**NW Natural Pre-Remedial Design Data Gaps Sampling
Gasco Sediments Site – Spring 2020
Field Change Request Form**

Project Name: Gasco Sediments Cleanup Action **Subconsultant:** Anchor QEA, LLC

Field Activity: Subsurface Sediment Sampling **Request Number:** 14

Field Change Request (FCR) Title: Additional Perimeter Subsurface Sediment Core Collection and Analyses to Determine Final Project Area

Figure 1
Proposed Additional Subsurface Sediment Core Locations
 Field Change Request No. 14
 Gasco Sediments Cleanup Action

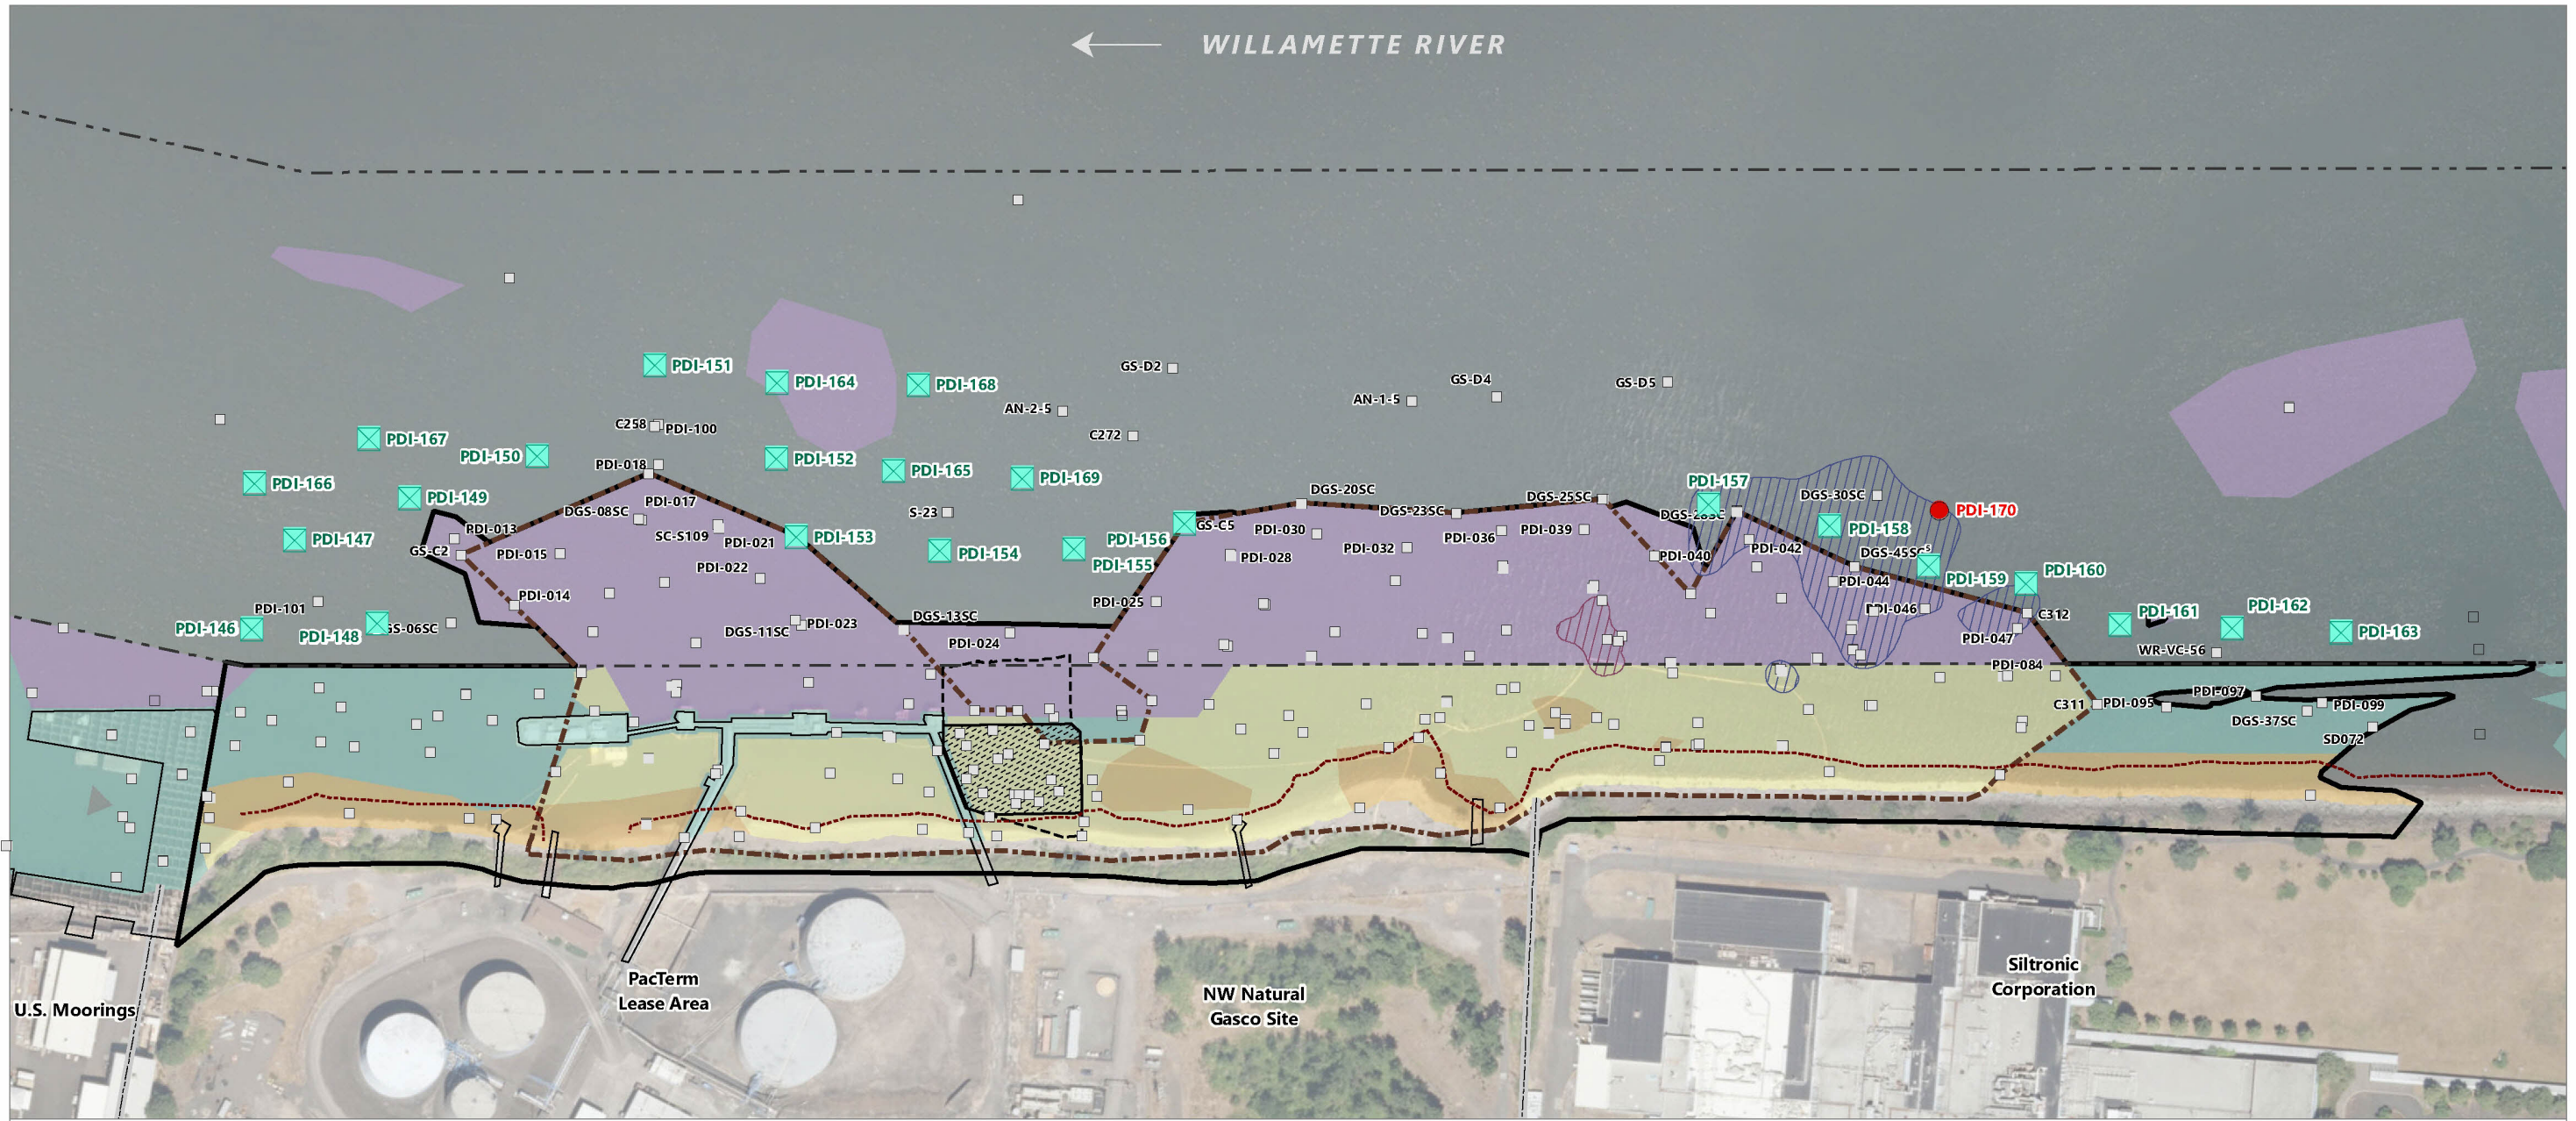
Description
<p>On April 16, 2020, NW Natural received approval from the U.S. Environmental Protection Agency (EPA) on Field Change Request Form No. 10 (FCR 10). FCR 10 described the rationale and approach for the collection of 18 additional perimeter subsurface sediment cores and analyses to determine the Final Project Area. The coring work was started on April 20, 2020, and all of these additional subsurface sediment cores have been successfully collected and processed with preliminary chemistry results received from the analytical laboratory. In addition, preliminary chemistry results have also been received on several cores collected pursuant to the EPA-approved FCR 12 dated April 24, 2020, and FCR 13 dated May 8, 2020. Preliminary chemistry results from one location (PDI-159 [Figure 1]) identified sediment concentrations exceeding the Record of Decision Table 21 total polycyclic aromatic hydrocarbon remedial action levels (RALs). Due to these preliminary chemistry results, and in order to collect all necessary data for remedial design during this mobilization, NW Natural proposes to collect one additional sediment core to bound potential RAL exceedances.</p>

Recommended Change
<p>NW Natural proposes to collect one additional sediment core less than 150 feet from locations PDI-158, PDI-159, and PDI-160 at the station shown in Figure 1 with the geographic coordinates provided in Table 1. The samples will be collected, processed, and submitted for chemical analysis consistent with FCR 10.</p>
